Re: Undi Commerce Park – *Technical Review 1*
PA 22008

After preliminary review of the above referenced proposal, the Planning Division has the following comments:

SUBJECT: PA 22-008 – Undi Commerce Park

Sheet Title:
**OVERALL
 SITE PLAN**

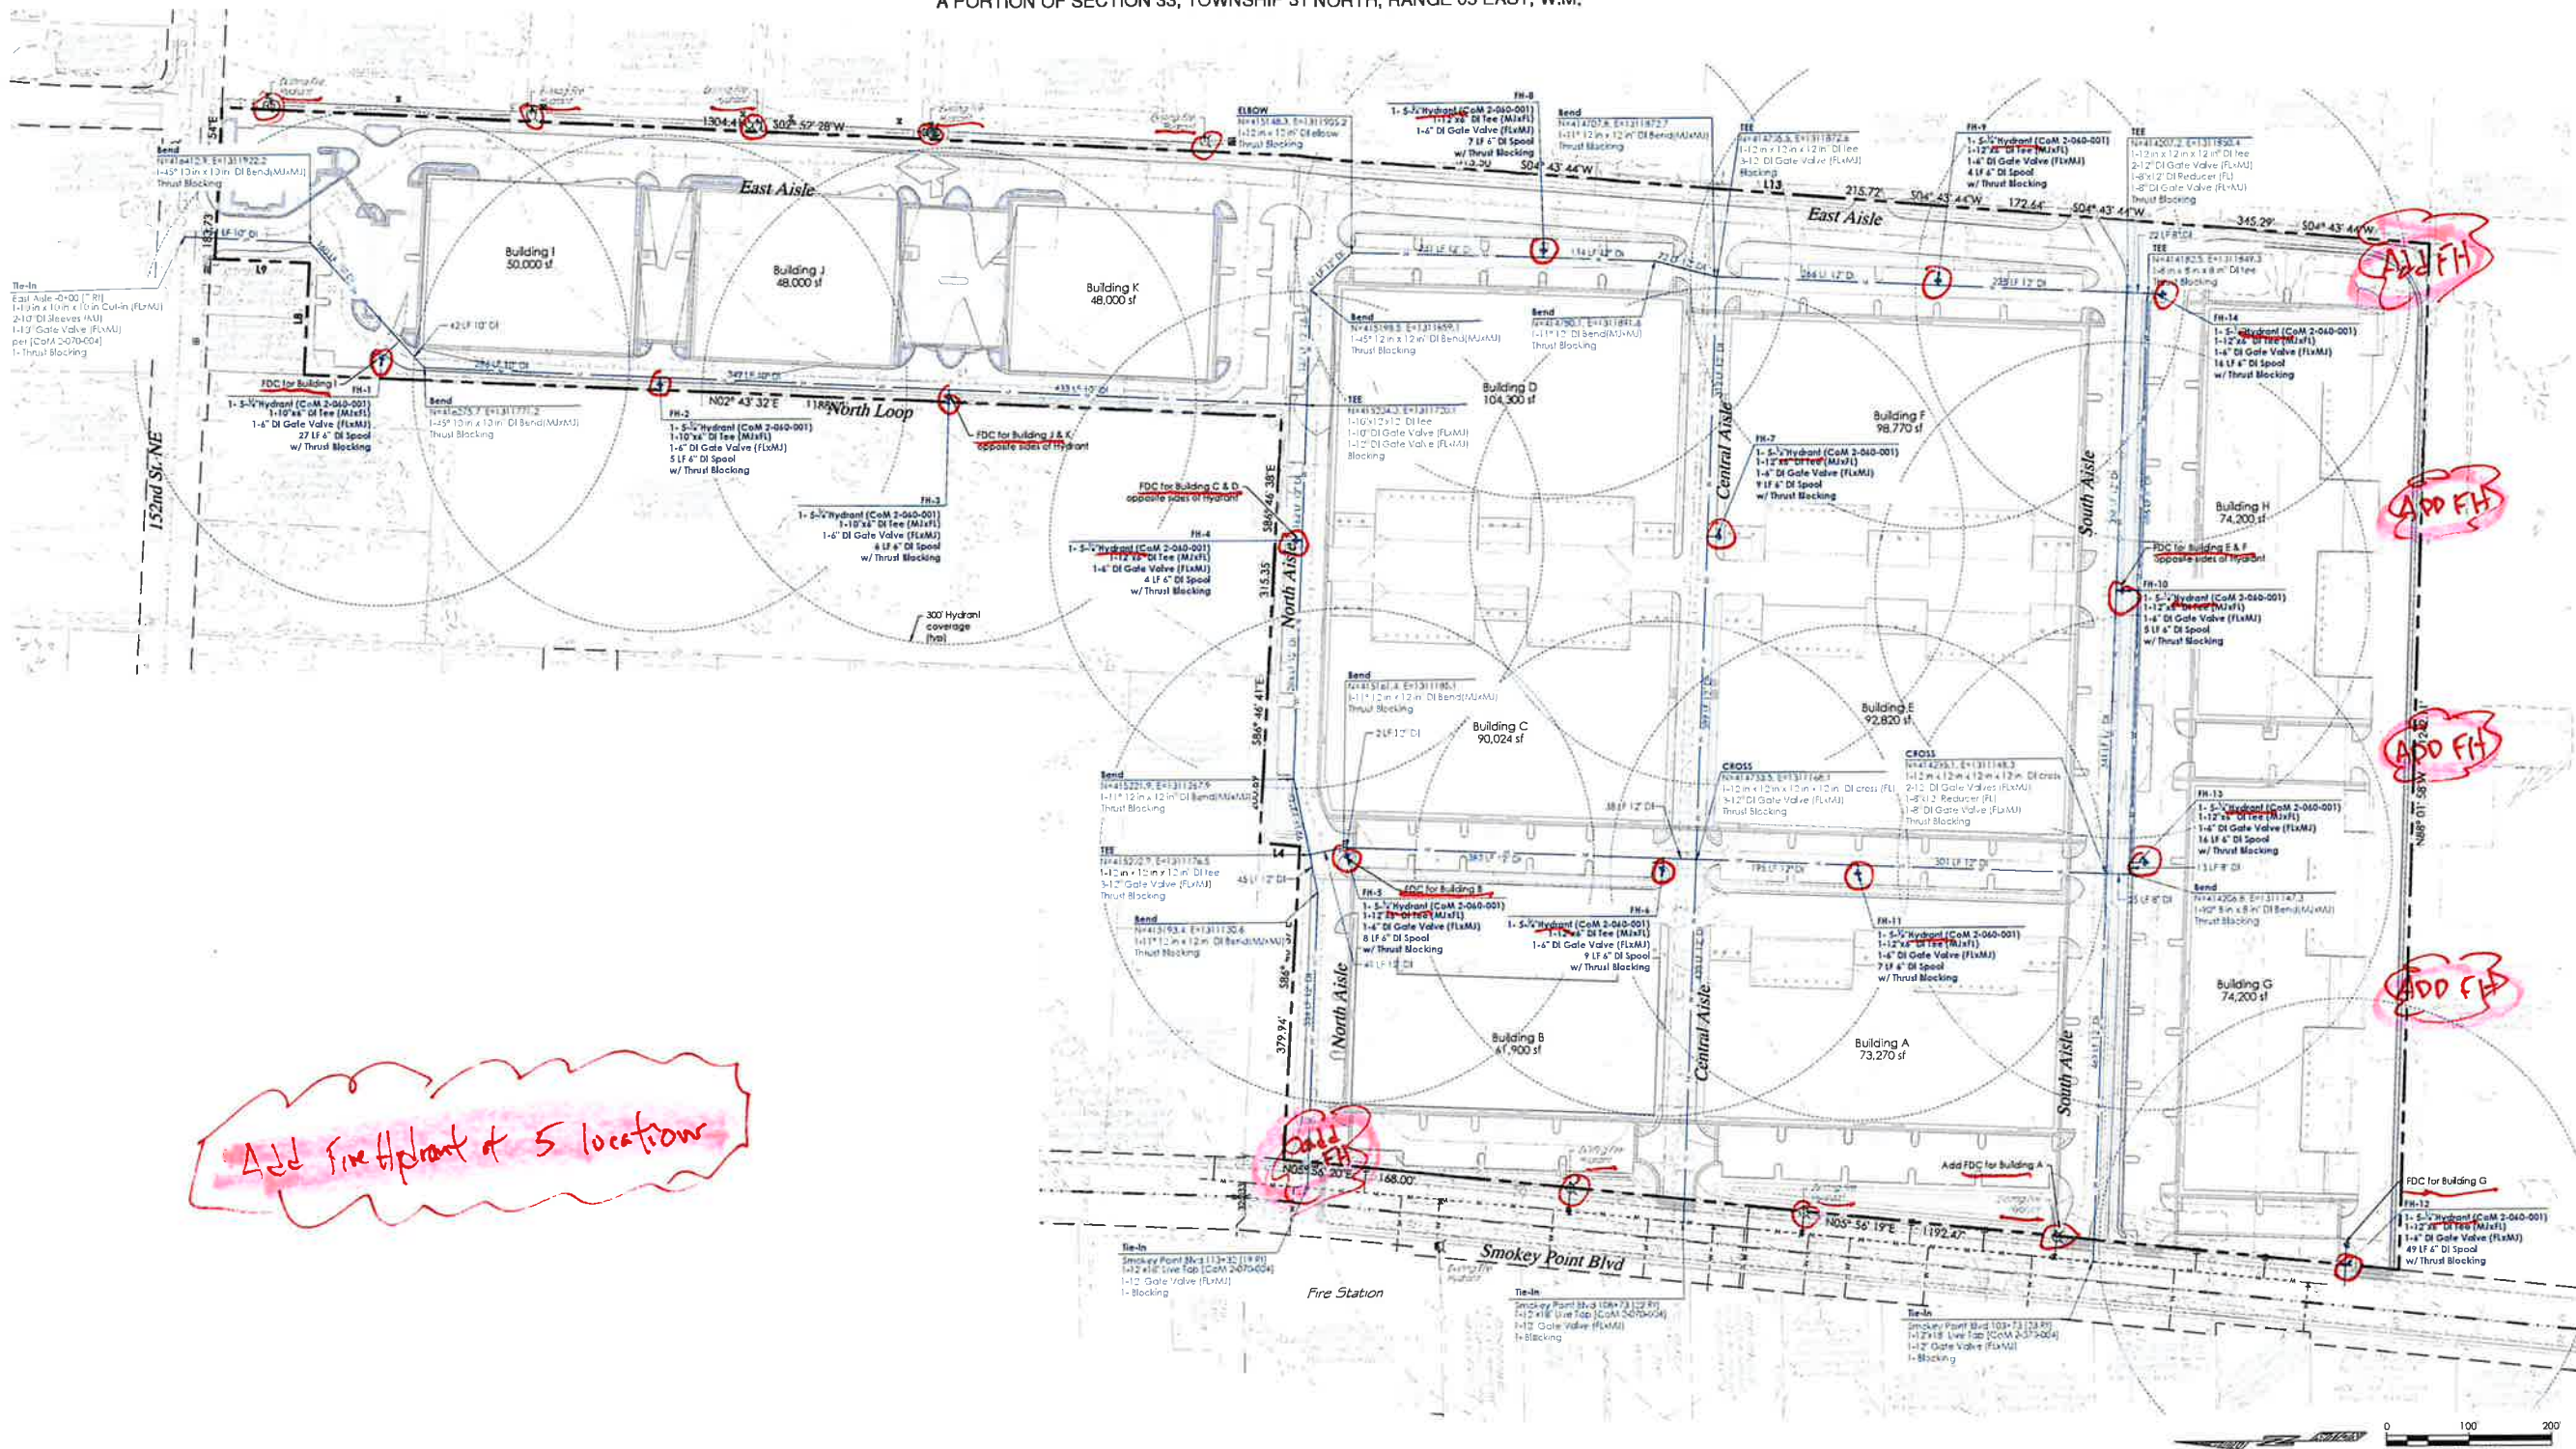
5. Sheet A0.1 – Overall Site Plan, shall be amended, as follows:
 - a. Pursuant to [MMC 22G.120.060](#)(3)(b), provide additional sheets at a reviewable scale (i.e. 1" = 20', 1"= 30', 1"= 40' or 1" = 50').

- b. The site plan shall be revised to comply with EDDS 3.301 *Arterial Access Management Standards*. See attached comments from Kacey Simon, Civil Plan Reviewer, dated April 14, 2022 and Jesse Hannahs, PE, Traffic Engineering Manager, dated April 27, 2022.

- c. Provide storage space and collection points for recyclables in accordance with [MMC 22C.020.320](#). Additionally, note the required SF calculations on the site plan, including area provided. This is in addition to the solid waste collection areas below.

- d. Provide collection points for solid waste. Contact Skip Knutsen, Public Works Service Manager, at 360.363.8173 or sknutsen@marysvillewa.gov, for solid waste collection area dimensional and location criteria.

- e. Thank you for referencing the minimum turning radii on the site plan. Depict actual turning radii proposed on site plan.
- f. Provide an auto-turn exhibit showing that the largest trucks navigating through the site will not damage any vertical curbs and landscape islands.
- g. Additional pedestrian connections traversing the proposed drive-aisles and in some instances landscape buffers, shall be provided per the attached redlines

Provide fire access through these two locations
